EPSTEIN RESIDENCE

MEZZANINE
FLOOR PLAN STUDY **A**

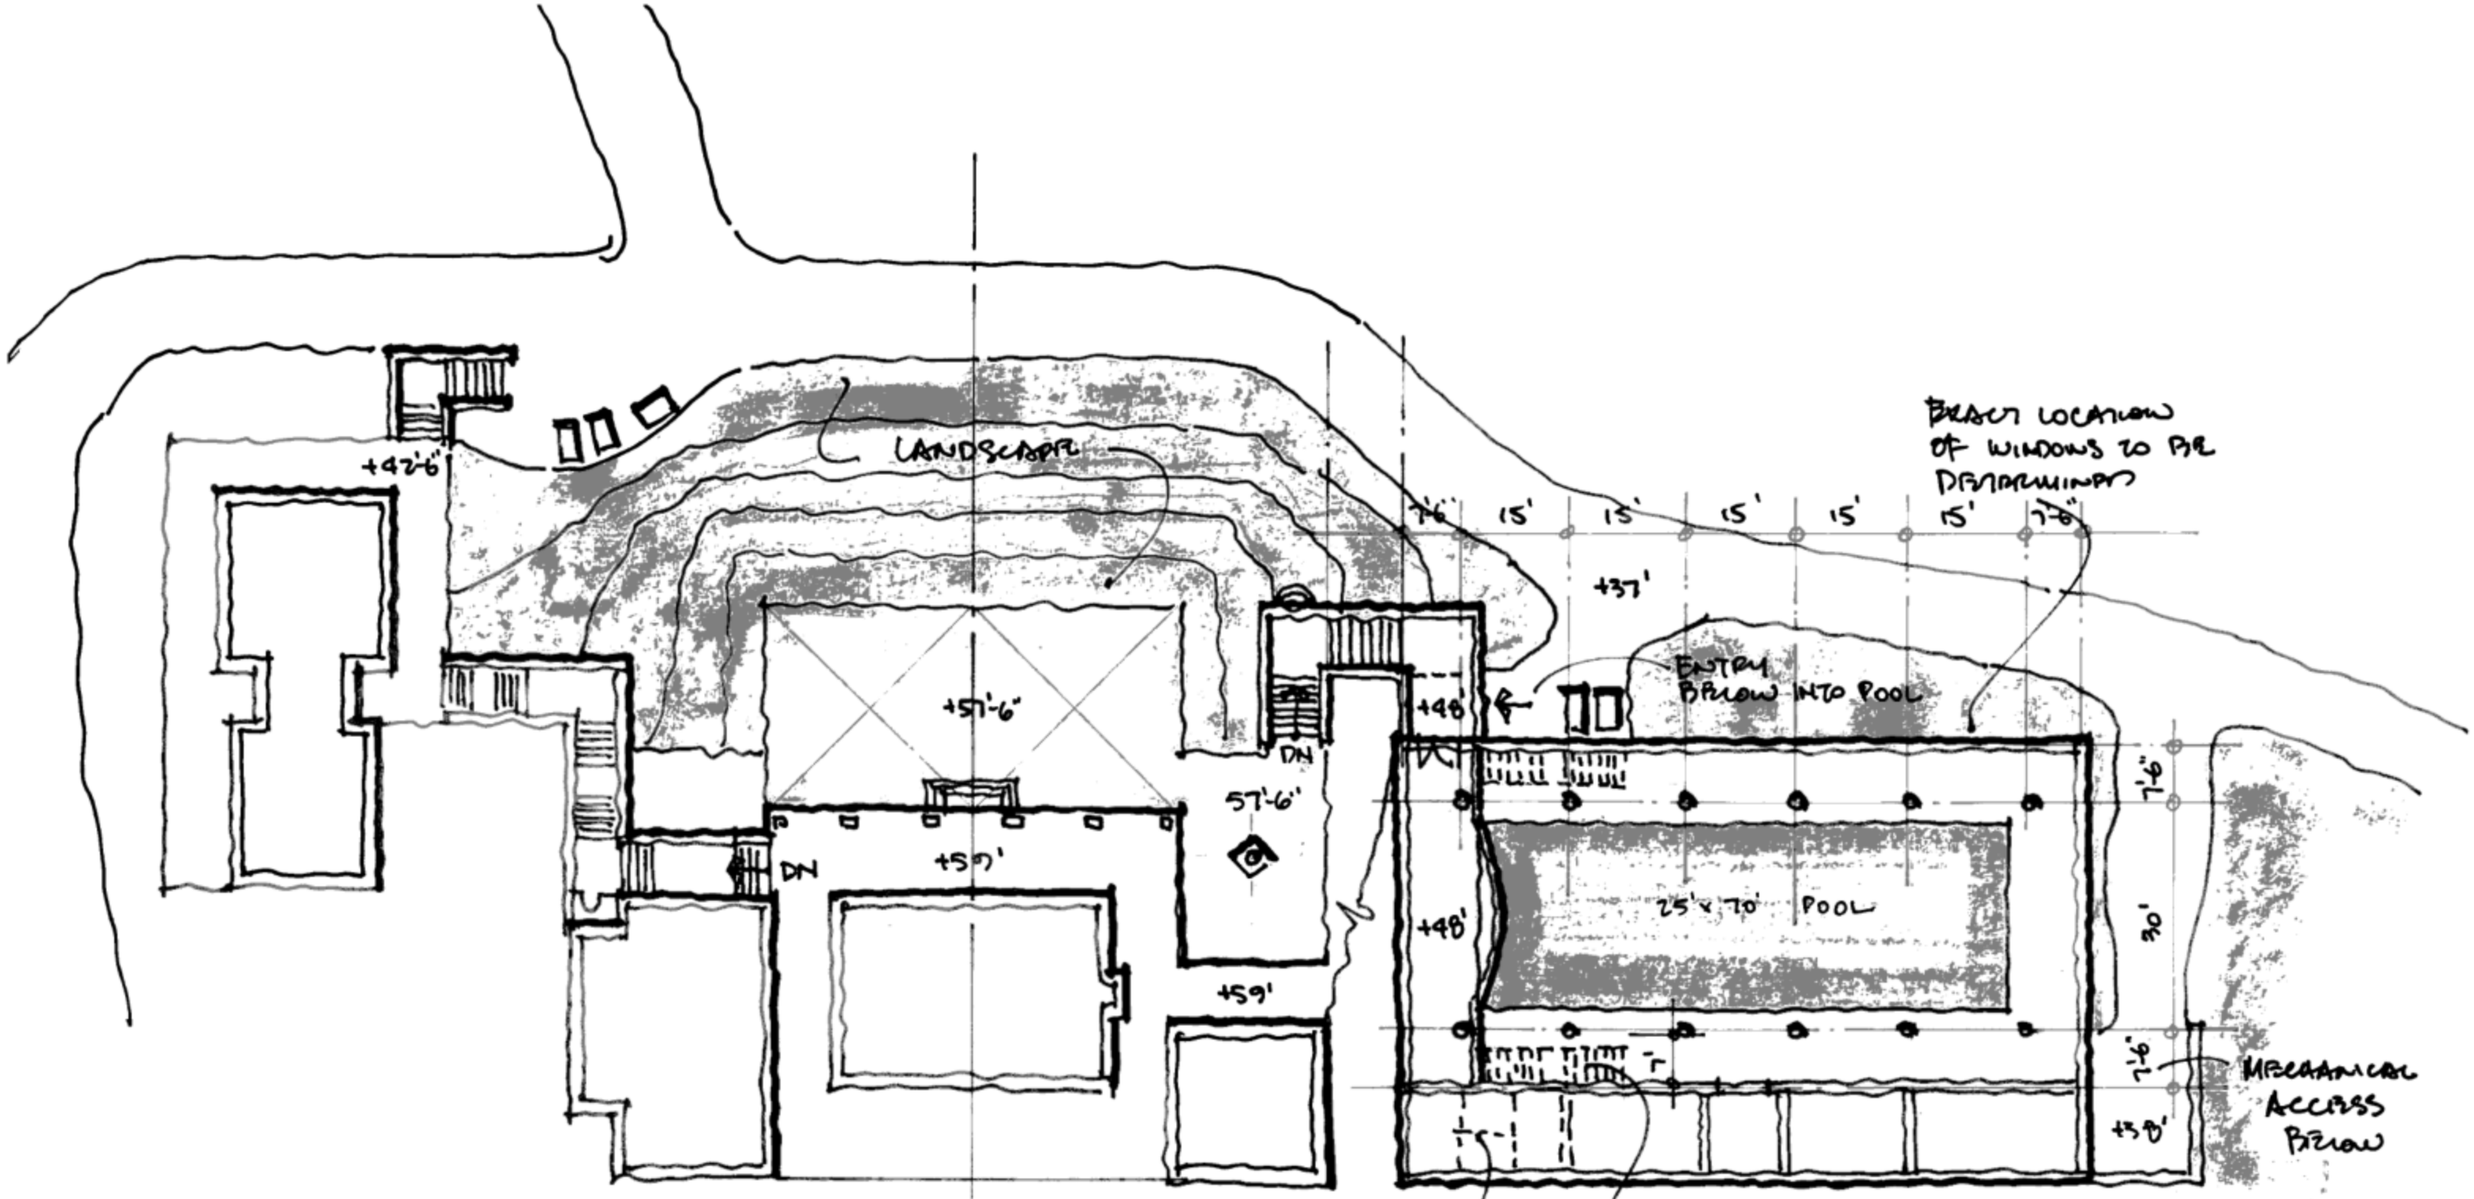
B) ALTERNATE LOCATION FOR STAIRS. ASYMMETRICAL.

A) THIS AREA IS TOO NARROW FOR A STAIR. AT 7' CLEAR, THE STAIRS WILL HAVE TO BE 3' WIDE TO WALK AROUND THE COLUMN BELOW.
